## **ADDENDUM NO. 2**

Public Paving, Drainage, Water, Sanitary Sewer, Street  
Light & Traffic Signal  
Improvements

Intermodal Parkway BNSF to Old FM 156

**CITY PROJECT NO.:** 103332

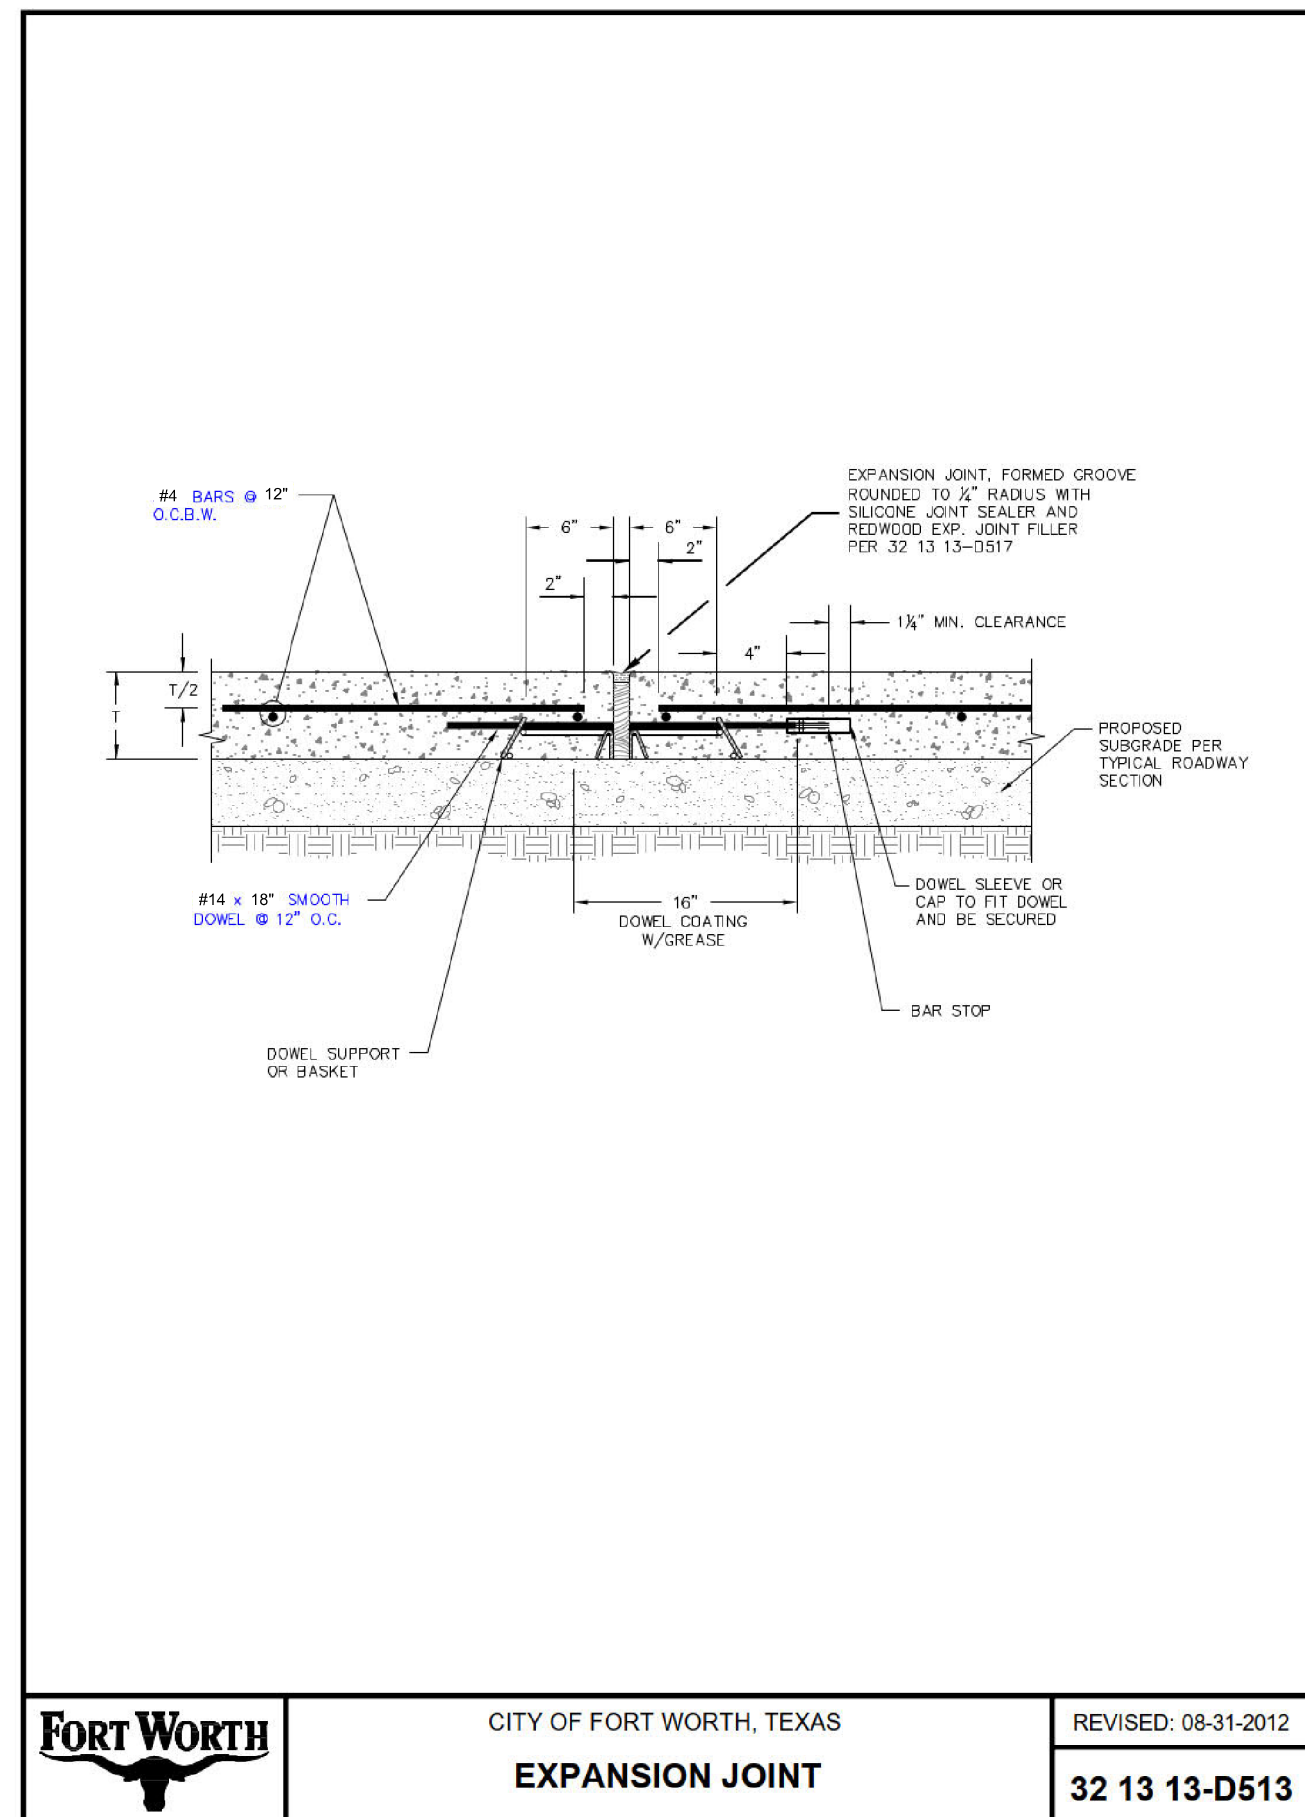
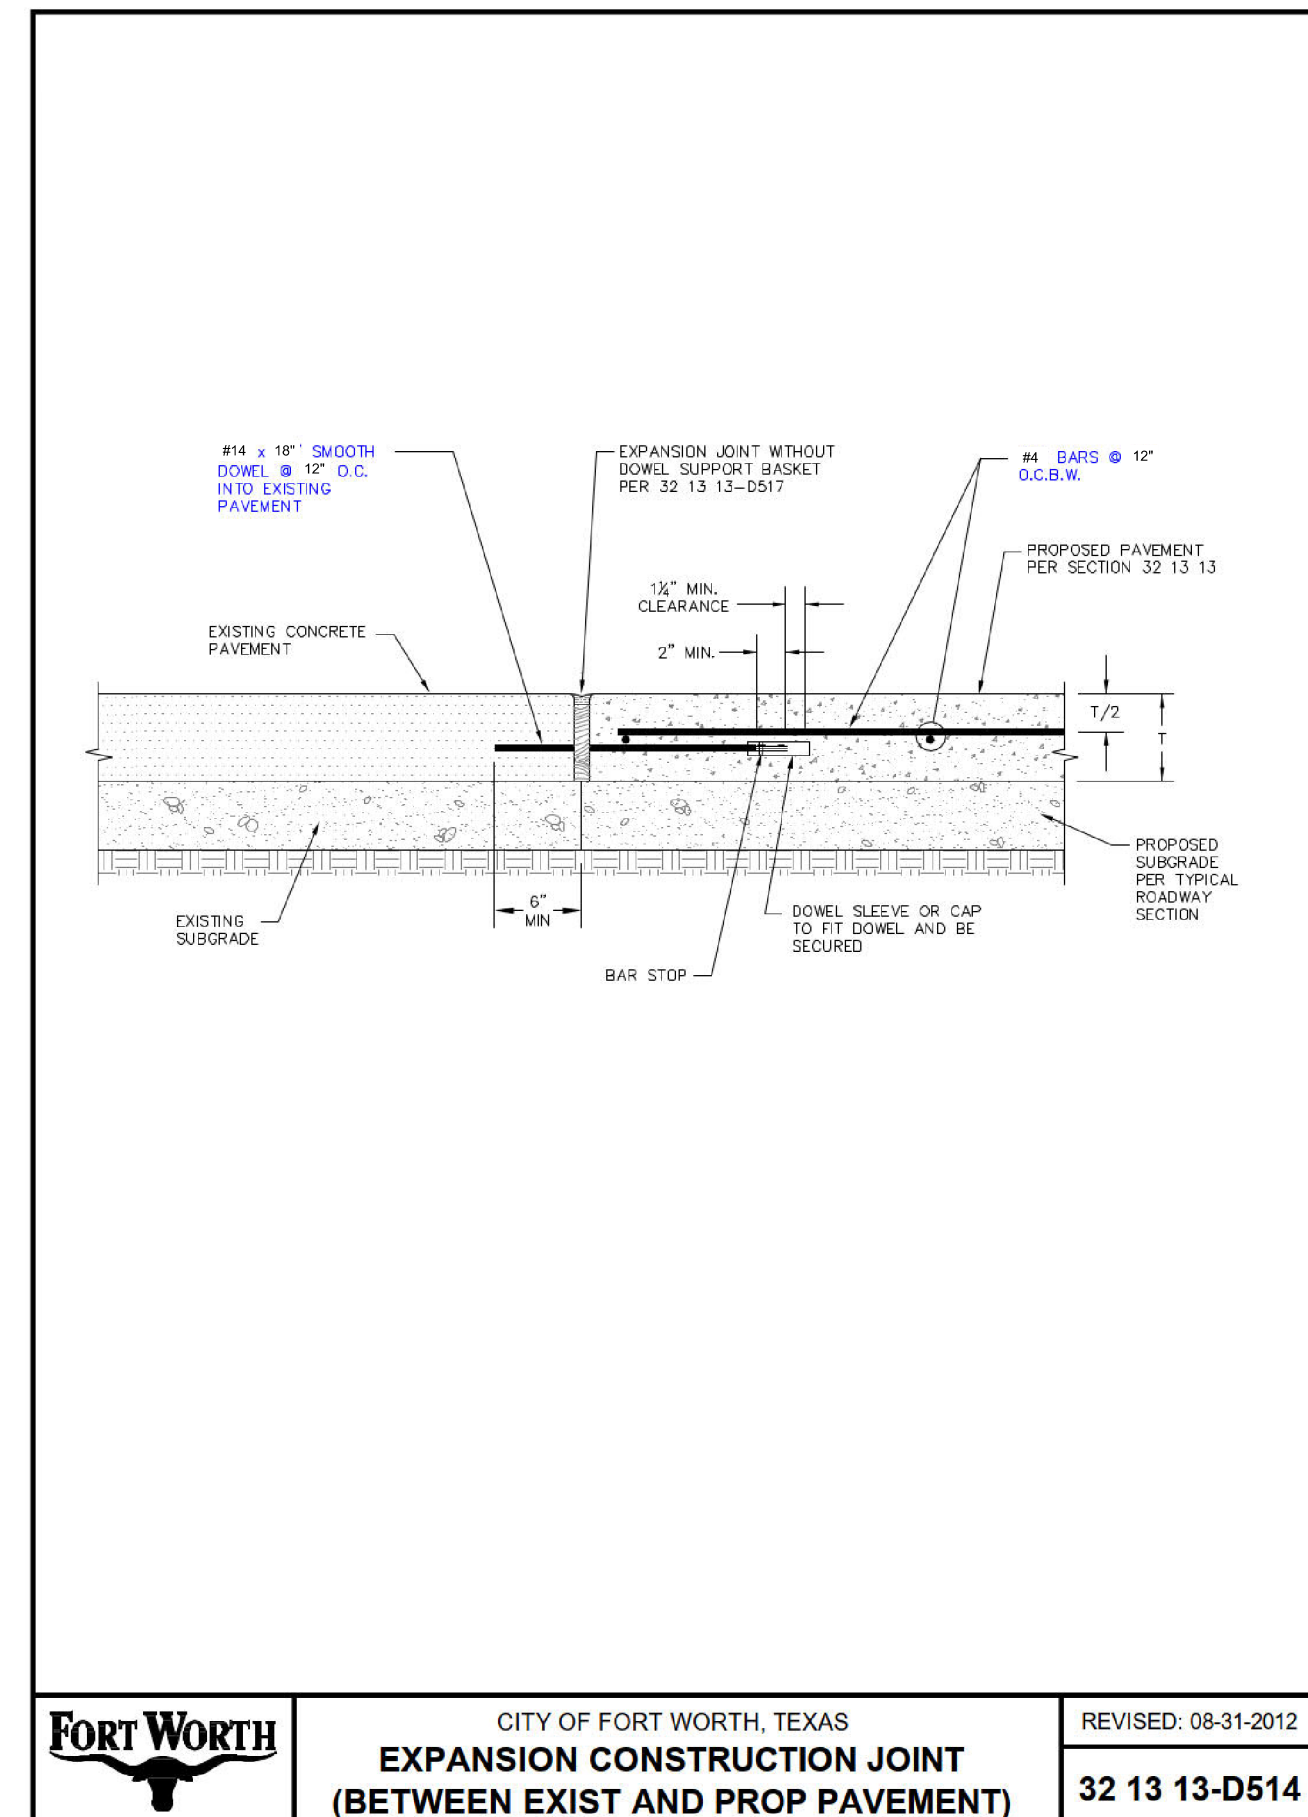
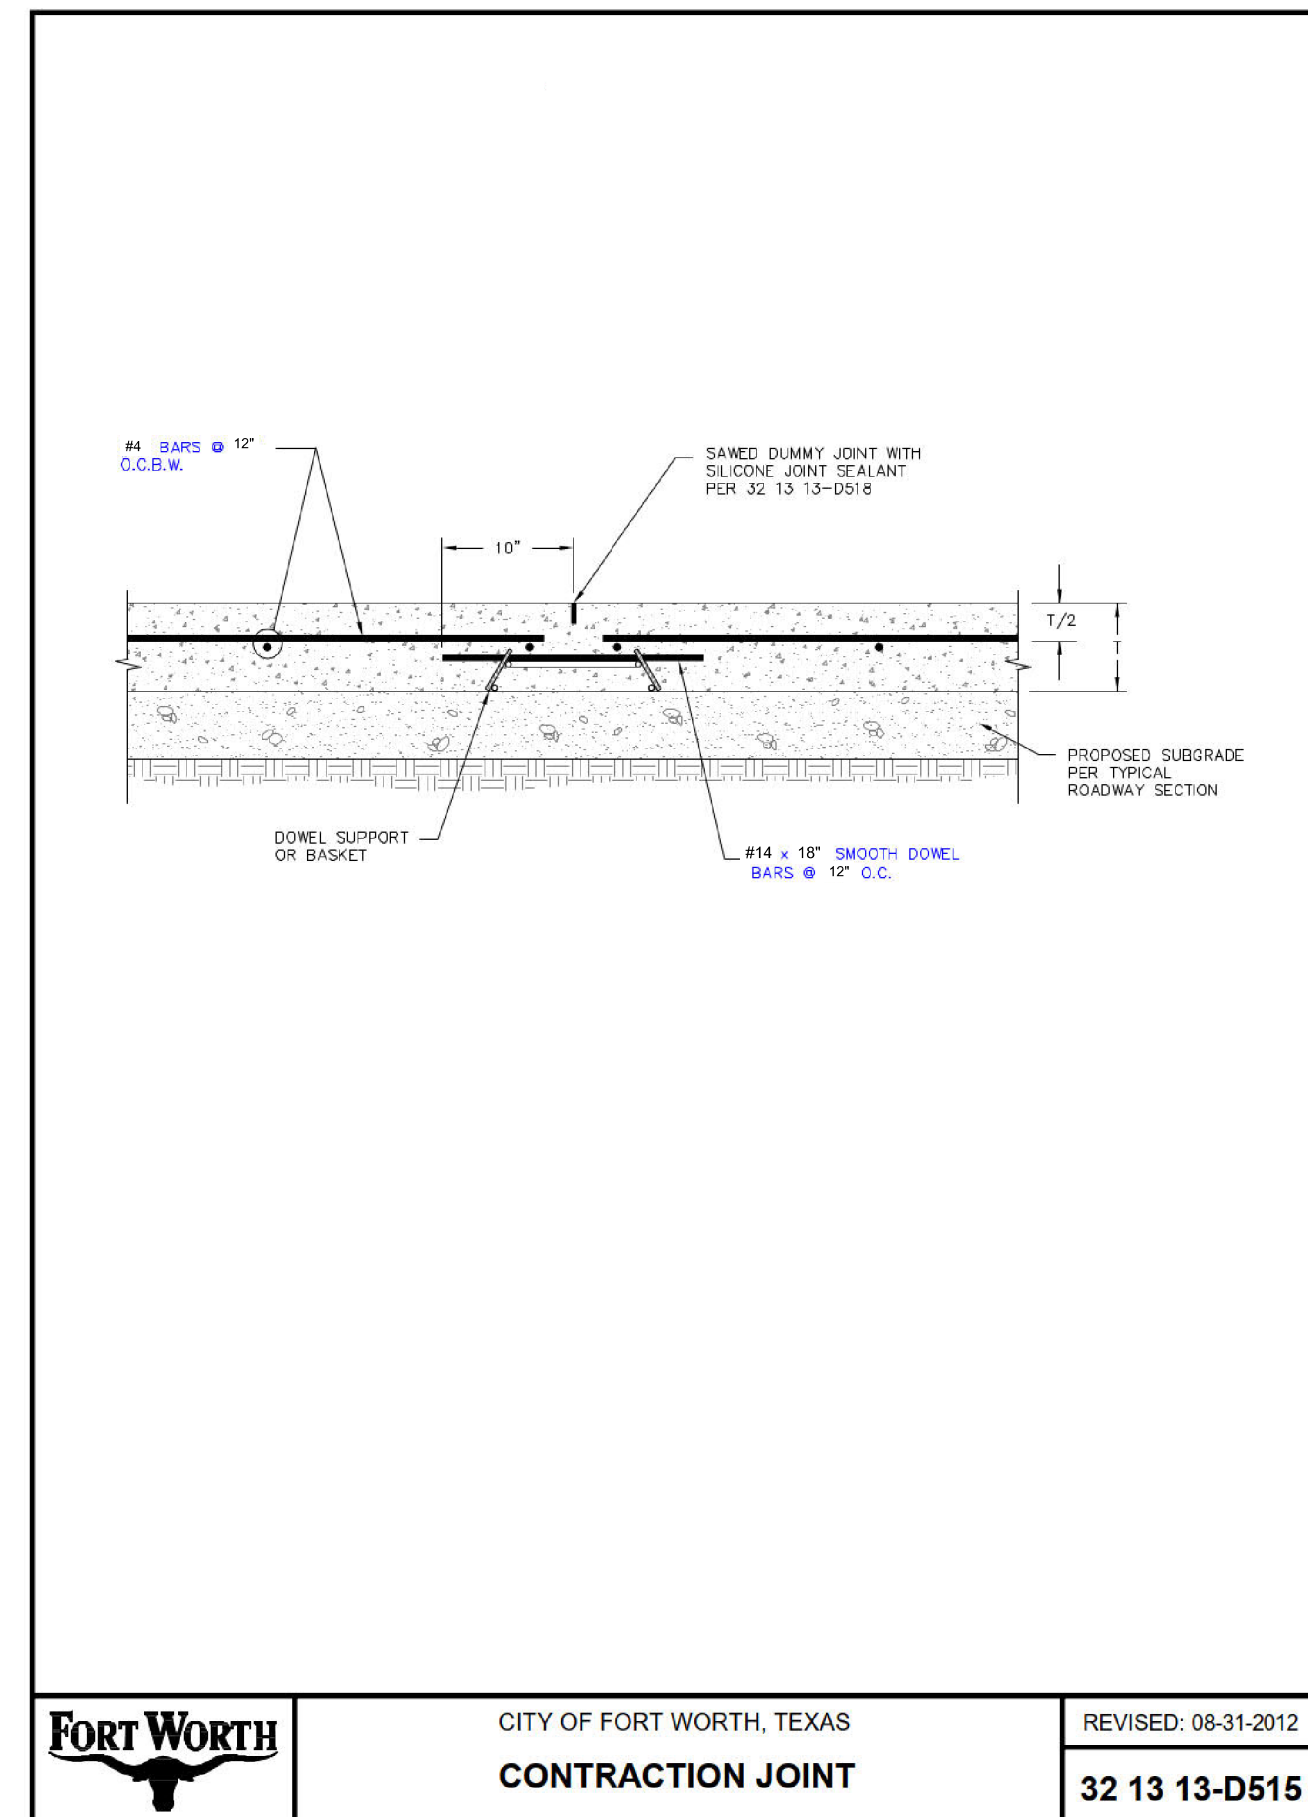
12. Document Modified: Plan Sheet C510 and C511.

Description of Change: The expansion joint dowel callouts have been revised to match on both sheets. The expansion joint dowels are #14 rebar @ 12" O.C.E.W and 18" in length.
